Access Compliance Report

Public Rights-of-Way

(Curb Ramps)

Intersection ID: 50587	Main Street: DOWNY_BIRCH_RD	Cross Street: GREAT_LAUREL_RD	Location: NE
ADA ID: 97382F24C862	Ramp Type: Perp	Initial Pass/Fail: Fail	Overall Compliance: No
Severity Score: 10			
Codes/Mitigation Info/Possible Solution		Field Measurements/Component Compliance

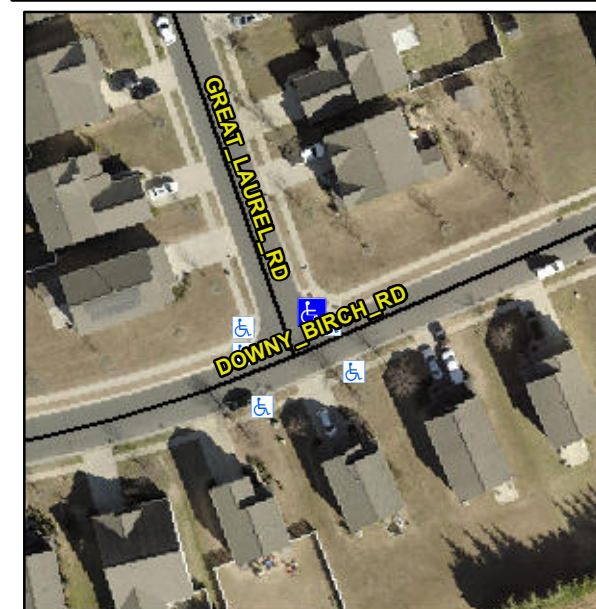
Not Found, R304.5.1, R304.5.3

Compliance	Description	Data	Compliance	Description	Data
N/A	Ramp Length (in)	49.5	Yes	Ramp Slope (%)	6.0
No	Ramp Width (in)	46.5	No	Ramp XSlope (%)	4.8
N/A	Flare Type LT	N/A	N/A	Flare Type RT	N/A
N/A	Flare Slope LT (%)	N/A	N/A	Flare Slope RT (%)	N/A
N/A	Flare Traversable LT?	N/A	N/A	Flare Traversable RT?	N/A
N/A	Landing Length (in)	N/A	N/A	DWS Provided?	N/A
N/A	Landing Width (in)	N/A	N/A	DWS Contrast?	N/A
N/A	Landing Slope (%)	N/A	N/A	DWS Length (in)	N/A
N/A	Landing X Slope (%)	N/A	N/A	DWS Full Width?	N/A
N/A	Landing Curb? (Y/N)	N/A	N/A	DWS Offset (in)	N/A
N/A	Shared Landing?	N/A			
N/A	Gutter Ponding?	N/A	N/A	Gutter Slope (%)	N/A
N/A	Gutter Lip Ht (in)	N/A	N/A	Gutter X Slope (%)	N/A
N/A	Painted X Walk1?	No	N/A	Painted X Walk2?	N/A
	X Walk 1 Direction	To W		X Walk 2 Direction	N/A
N/A	X Walk 1 Width (in)	N/A	N/A	X Walk 2 Width (in)	N/A
	X Walk 1 Slope (%)	0.1		X Walk 2 Slope (%)	N/A
	X Walk 1 X Slope (%)	3.3		X Walk 2 X Slope (%)	N/A

Remove & Replace Entire Ramp.
